1984 Revision
84-070

State of Alaska
Department of Fish and Game
Public Review Nomination for Waters
Important to Anadromous Species

Name of Waterbody (if known): 306-70-10300

SUBJECT: November 2 & 7 Telephone Conversations

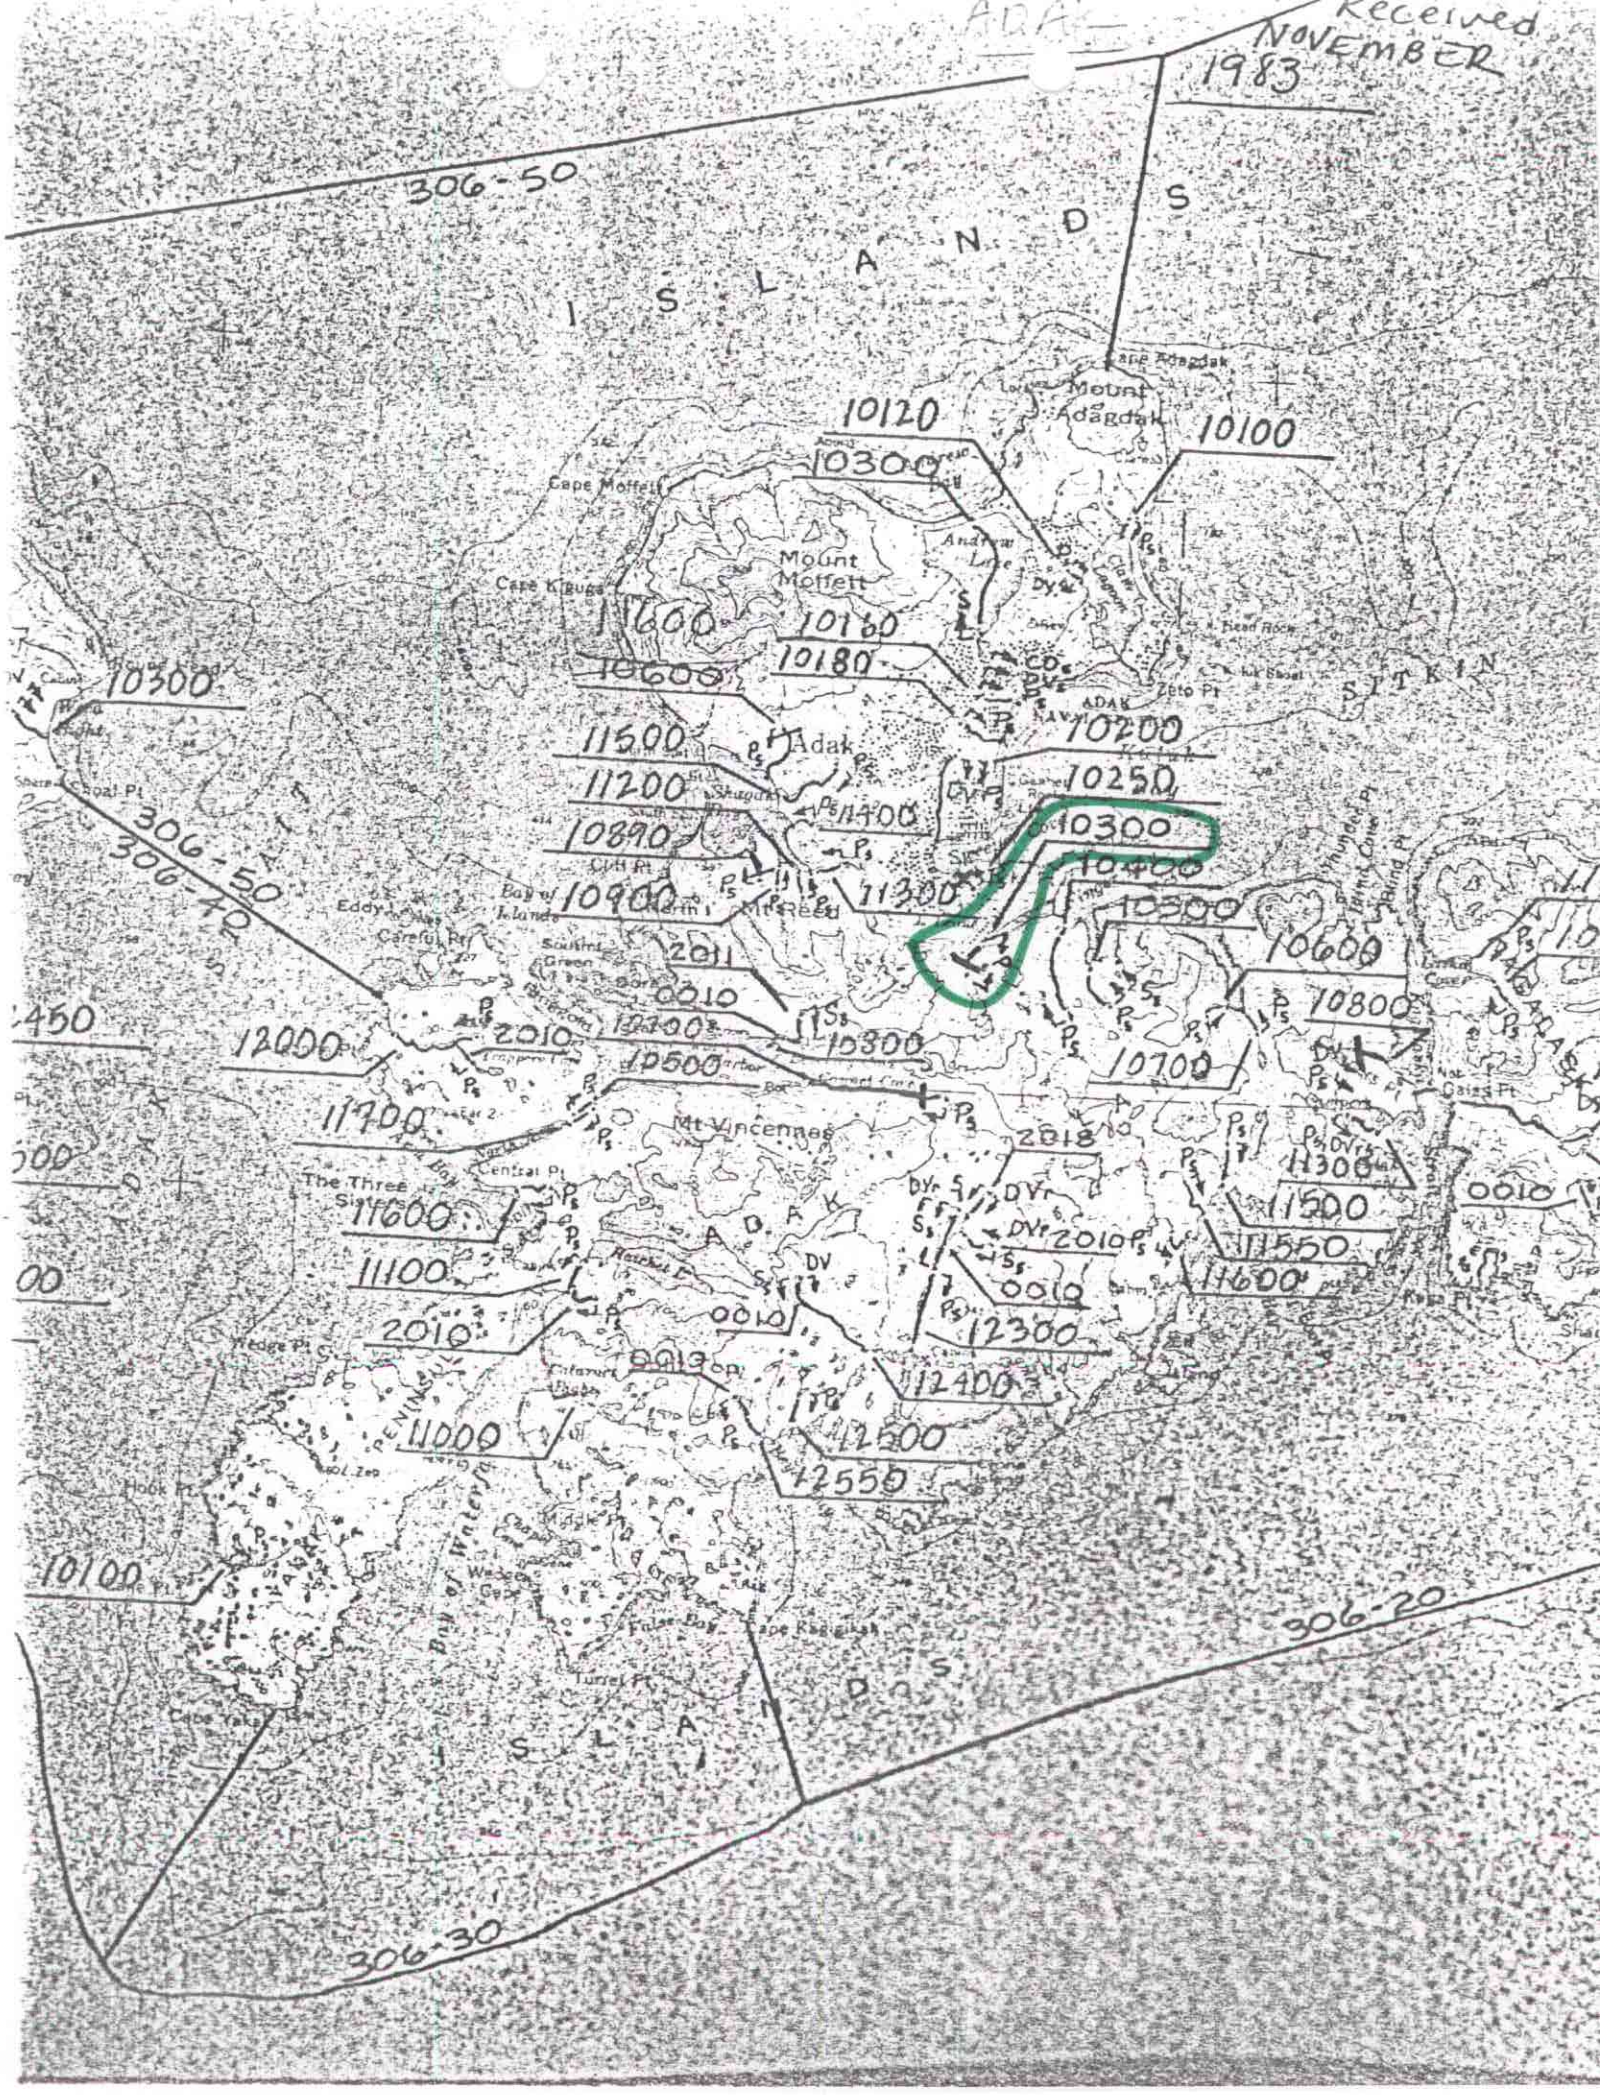
Stream was drafted too long. Please correct upper point. Reference map and memorandum from Pat Holmes. Holmes also requested that it be shortened in 1983 (1983 map attached).

Your cartographer or possibly myself were a bit loose with the pen or outlining the length of a few streams. I have included a map with corrections outlined in red.
